ROHDE & SCHWARZ

Release Notes

Firmware Update R&S[®] ESIB 4.34.4

for R&S[®] ESIB7, R&S[®] ESIB26, R&S[®] ESIB40

CISPR RMS-Detektor

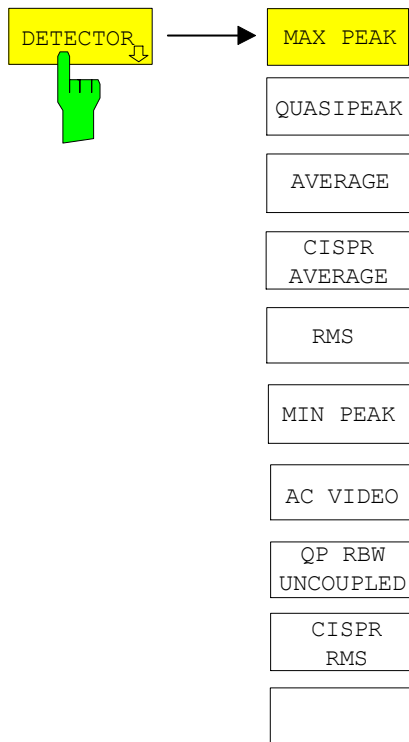
The weighting modes that can be selected have been extended by the detector CISPR RMS.

TRACE menu

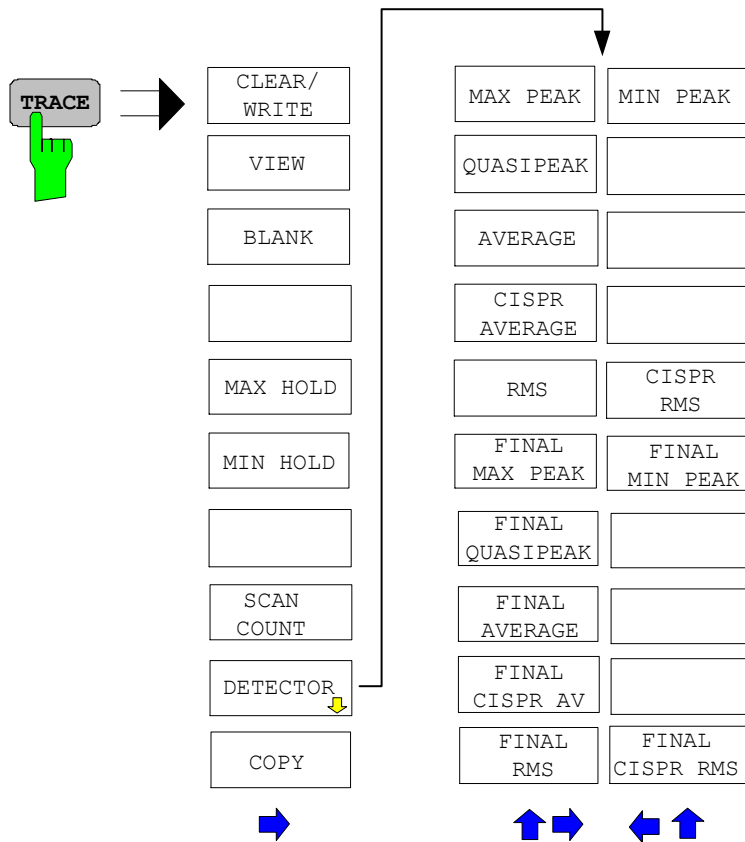
The *CISPR RMS* softkey activates the weighting detector according to a proposed amendment of CISPR 16-1-1 (CISPR/A/628/CD). The CISPR RMS average detector supplies a weighted reading of the input signal. When measuring the RMS-average according to the proposed amendment of CISPR 16-1-1, the maximum value of the RMS-average during the measurement time is displayed. The detector is used, for example, to measure pulsed sinusoidal signals with a low pulse repetition frequency. It is calibrated with the RMS value of an unmodulated sinusoidal signal. Averaging is with lowpass filters of the 2nd order (simulation of a mechanical instrument).

The *FINAL CISPR RMS* softkey selects the weighting rms detector according to CISPR 16-1-1 for the final measurement.
